# Access Compliance Report

## Public Rights-of-Way

Intersection ID: 14779	Main Street: ALBEMARLE_RD	Cross Street: MALLARD_DR	Location: NW
ADA ID: 8C8C03444AC7	Ramp Type: PerpDiag	Initial Pass/Fail: Fail	Overall Compliance: No
			Severity Score: 13.75

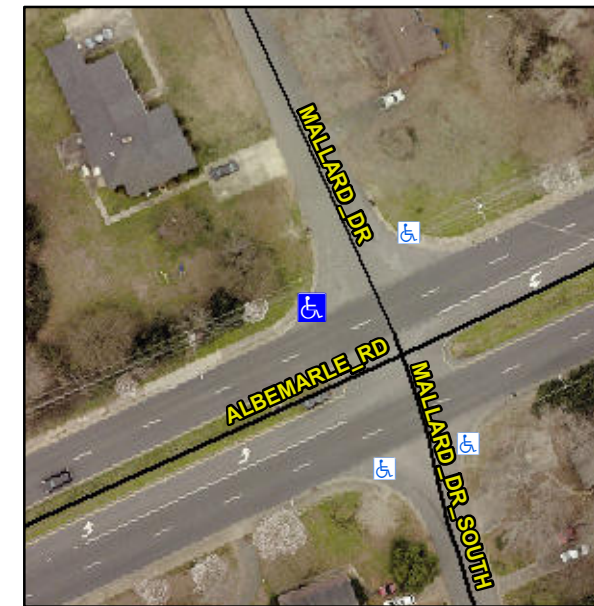
**Not Found, R304.2.2, R304.5.3**

Compliance	Description	Data	Compliance	Description	Data
N/A	Ramp Length (in)	59.0	No	Ramp Slope (%)	9.2
Yes	Ramp Width (in)	48.0	No	Ramp XSlope (%)	3.0
N/A	Flare Type LT	N/A	N/A	Flare Type RT	N/A
N/A	Flare Slope LT (%)	N/A	N/A	Flare Slope RT (%)	N/A
N/A	Flare Traversable LT?	N/A	N/A	Flare Traversable RT?	N/A
N/A	Landing Length (in)	N/A	N/A	DWS Provided?	N/A
N/A	Landing Width (in)	N/A	N/A	DWS Contrast?	N/A
N/A	Landing Slope (%)	N/A	N/A	DWS Length (in)	N/A
N/A	Landing X Slope (%)	N/A	N/A	DWS Full Width?	N/A
N/A	Landing Curb? (Y/N)	N/A	N/A	DWS Offset (in)	N/A
N/A	Shared Landing?	N/A			
N/A	Gutter Ponding?	N/A	N/A	Gutter Slope (%)	N/A
N/A	Gutter Lip Ht (in)	N/A	N/A	Gutter X Slope (%)	N/A
N/A	Painted X Walk1?	No	N/A	Painted X Walk2?	No
	X Walk 1 Direction	To S		X Walk 2 Direction	To E
N/A	X Walk 1 Width (in)	N/A	N/A	X Walk 2 Width (in)	N/A
	X Walk 1 Slope (%)	2.9		X Walk 2 Slope (%)	0.3
	X Walk 1 X Slope (%)	1.0		X Walk 2 X Slope (%)	3.1

**Remove & Replace Curb Ramp With Two New Directional Ramps or Equivalent.**
